Warragamba Dam Raising Project SSI-8441

Submission by Ted Woodley¹

17 December 2021

Figure 1 – Relative contribution of river catchments in the Valley (Figure 2 in EIS)

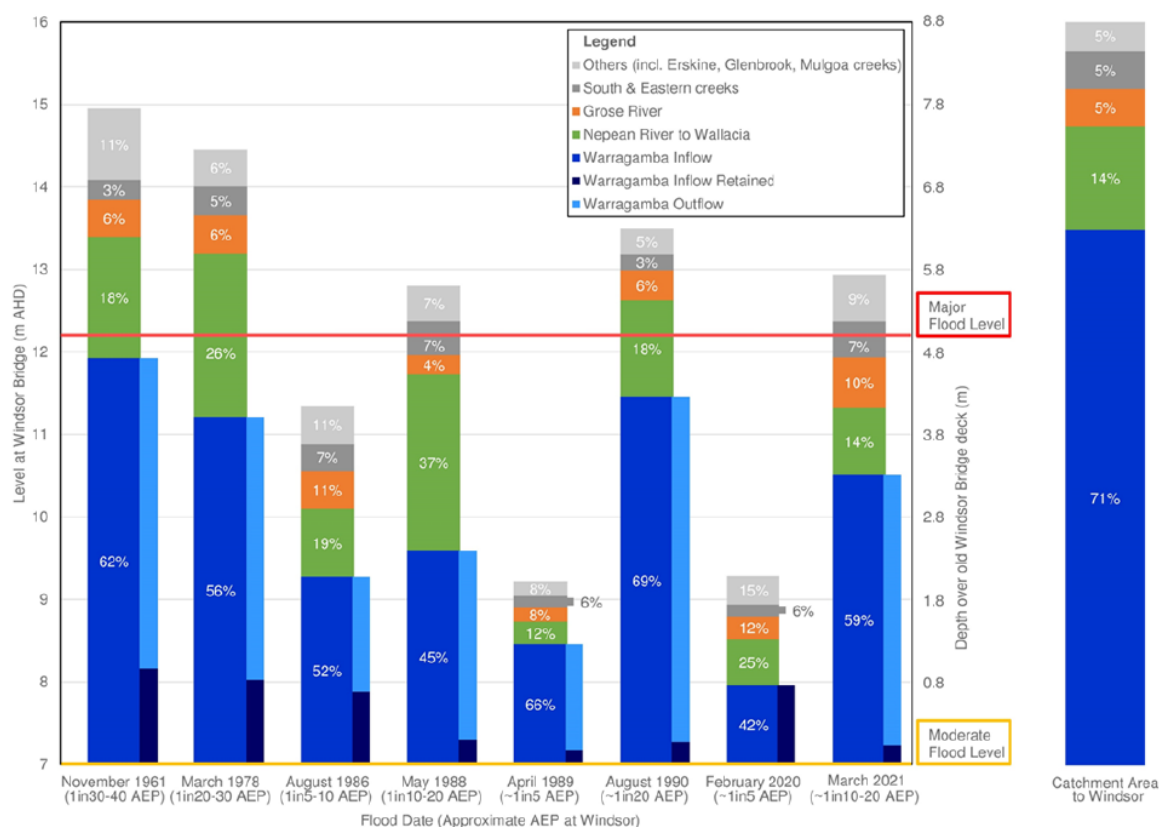
This statement is repeated throughout the EIS, but it is highly misleading and beside the point.

Figure 2 shows relative contributions from the Warragamba catchment for the eight largest floods in the sixty years since the Dam was commissioned. The Figure focuses on Warragamba inflows from its catchment (dark blue bars).

But inflows are irrelevant as far as downstream flooding is concerned, as is the ‘up to 70%’ contribution quote.

The only relevant contribution to flooding is the outflow from the Dam to the Valley (light blue bars), which is obviously less than the inflow by the amount retained in the Dam (black bars) – i.e. the spare capacity in the Dam at the time.

Figure 2 indicates that outflows from Warragamba Dam during the eight floods contributed 0% to

65% to downstream flooding, averaging slightly less than half:

- Warragamba Dam did not contribute at all to the February 2020 flood, as the Dam did not spill – it was at less than 50% capacity at the time.
- The maximum contribution to flooding from Warragamba Dam occurred in the August 1990 flood, at around 65%.

Figure 2 – Discharge Hydrograph for 1 in 100 Year Flood (Figure 15-36 in EIS)

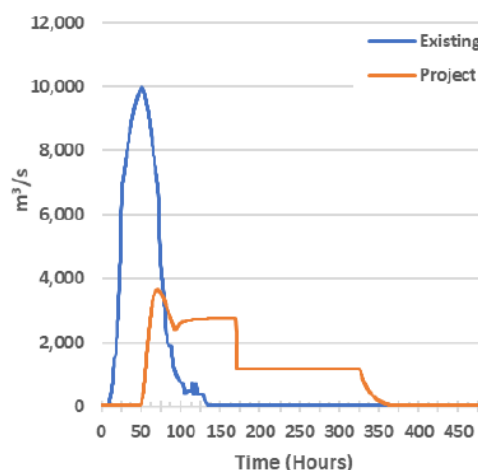
The graph indicates that all inflows up to that time, when the flood peaks, are contained in the FMZ, and that the subsequent releases are controlled according to the proposed drawdown procedure outlined in Section 2.3.

However, Figure 5 indicates that a 1 in 100-year flood would reach 15.3 metres above FSL, 3.3 metres over the crest of the central spillway and 1.3 metres over the auxiliary spillway, resulting in uncontrolled spilling from both spillways. This uncontrolled discharge is not evident in Figure 2. Can this apparent anomaly be explained?

If Figure 2 is in error, the downstream flows from Warragamba will be much higher and possibly start earlier than indicated. If so, the flood mitigation benefits of the dam raising will have been overestimated. The impact of this misrepresentation would be even more acute for a flood of greater than 1 in 100-years.

Figure 4 – Dam wall: Depth-duration curves (Figure 15-30 in EIS)

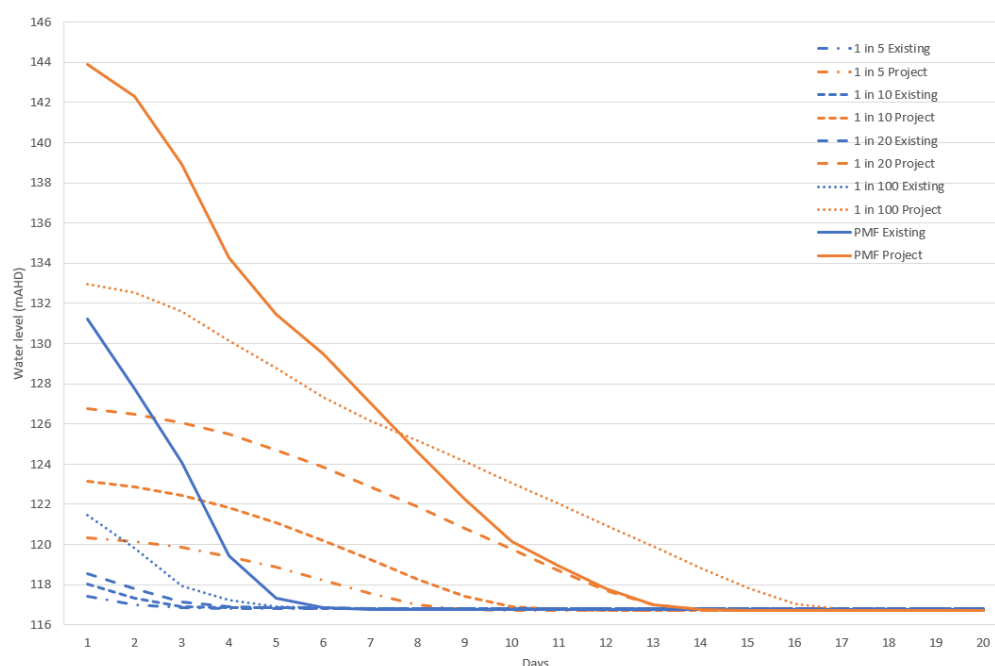
The information provided in these figures is incorrect and inconsistent. The title in Figure 3 under Project should be 'Increase in Depth (m)', not 'Depth (m)', while the time for emptying the FMZ after a 1 in 100-year flood is shown as 4.0 days (existing) and 14.8 days (Project) in Figure 3 but 5.5 days and 16.5 days in Figure 4.

A minor point noted earlier is the slightly longer durations for a 1 in 100-year flood of 14.8 days (Figure 3) and 16.5 days (Figure 4).

Figure 7 – Historic Dam levels (Figure 15-8 in EIS)

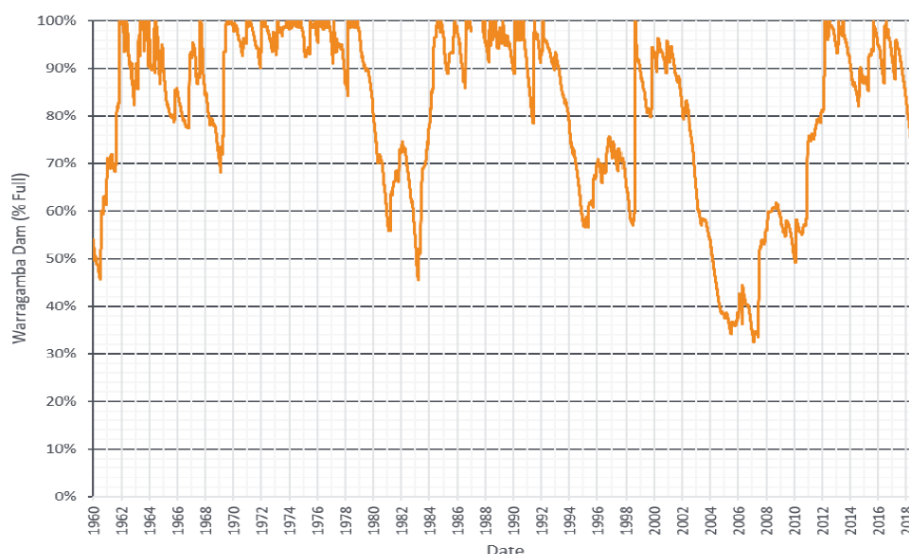
It is comforting to note that the historic levels of Warragamba have been relatively high (see Figure 7), never dropping below 30%. Had a regime been in place to lower the FSL to 82% when a flood was looming, the only time this may have triggered the need for alternate water supplies would have been once in the past sixty years (2004 – 2008).
